Subject: In the Matter of  
Texas Utilities Electric Co., et al.  
Comanche Peak Steam Electric Station  
Units 1 and 2

Subject: Allegation No. OSP-86-A-0148 (4-86-A-005)

Staff Evaluation of Pipe Support Allegations

SUBJECT: COMANCHE PEAK STEAM ELECTRIC STATION (CPSES)  
DOCKET NOS. 50-445 AND 50-446  
ALLEGATIONS OF DESIGN AND CONSTRUCTION DEFICIENCIES

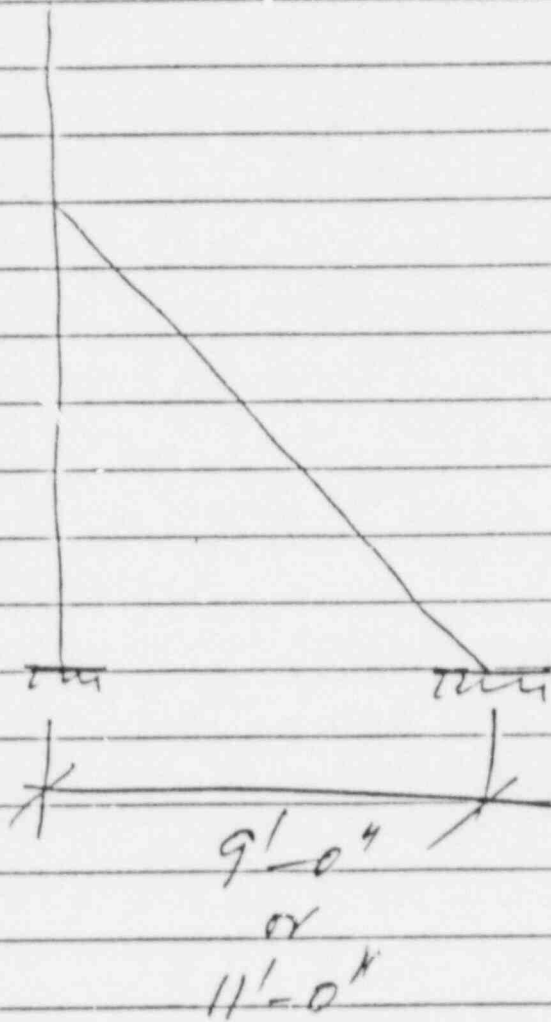
There is a concern that the correct value of slenderness ratio,  $K$ , when rigid struts are used connected to another structural member, such as a wide flange or structural tube (see Exhibit 2). It is not sure whether the  $K$ -value was correctly considered.

Exhibit 1

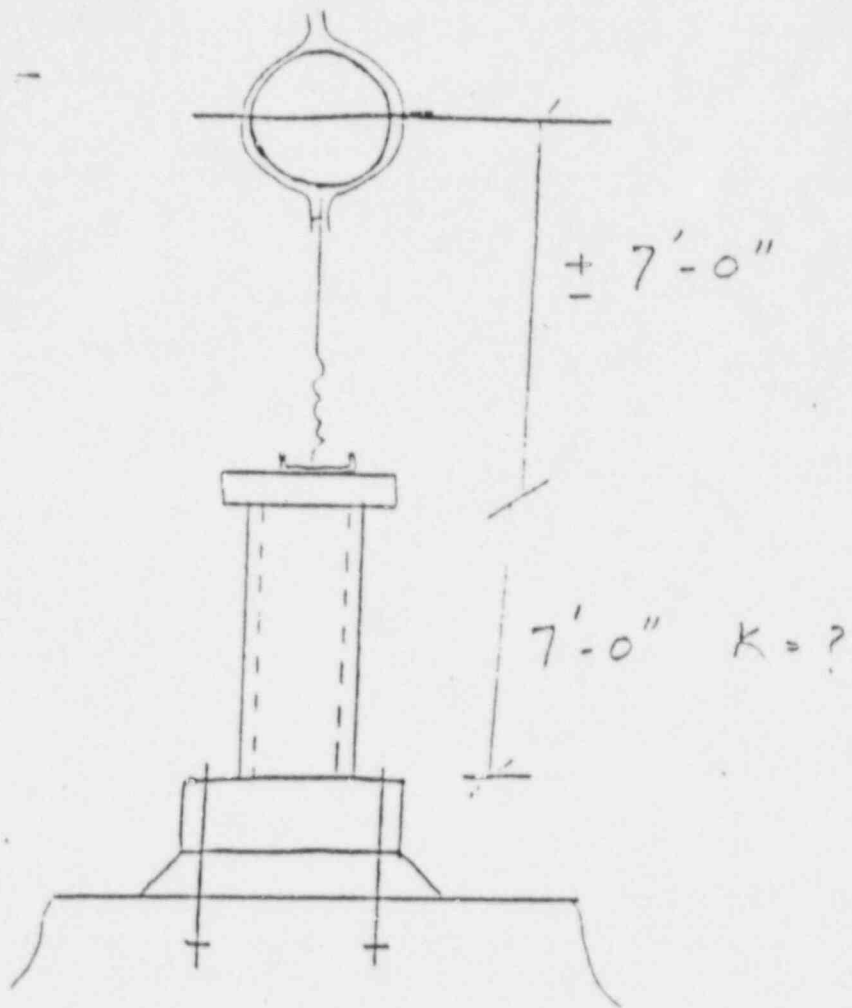
<u>Item #</u>	<u>Description of Concern</u>
17	There is a question as to the validity of the use of the specified allowable loads for the spacing of adjacent Hilti bolts when the spacing is less than 10 bolt diameters. This should be investigated (No specific design).
18	There is a question as to the allowable load that should be used for the design of Hilti bolts when they are located near equipment that vibrates. If a higher factor of safety is to be used, the basis for this allowable load should be explained (No specific design).
19	There is a concern that a minimum size baseplate should be used on the CPSES project. Other projects have a 3/4" minimum plate thickness by specification. There are some large structural frames at Comanche Peak that have baseplates as thin as 3/8", which can cause warpage in the baseplate due to welding (No specific design).
20	A question has been raised concerning the design/ structural adequacy of a support structure contained in a re-modification package of about 100 supports selected by the CPRT. The sketch is shown as Exhibit No. 1.

A question has been raised concerning the design/structural adequacy of a support structure contained in a remodification package of about 100 supports selected by the CPRT. The sketch is shown as Exhibit No. 1.

The sketch in Exhibit 1 does not portray SB3-2 (as noted on the Exhibit) but appears to portray support SW-1-031-009-J05R. Support SB3-2 is currently being design validated by SWEC. Support SW-1-031-009-J05R has been requalified by SWEC in accordance with CPPP-7 and found acceptable with no modifications.
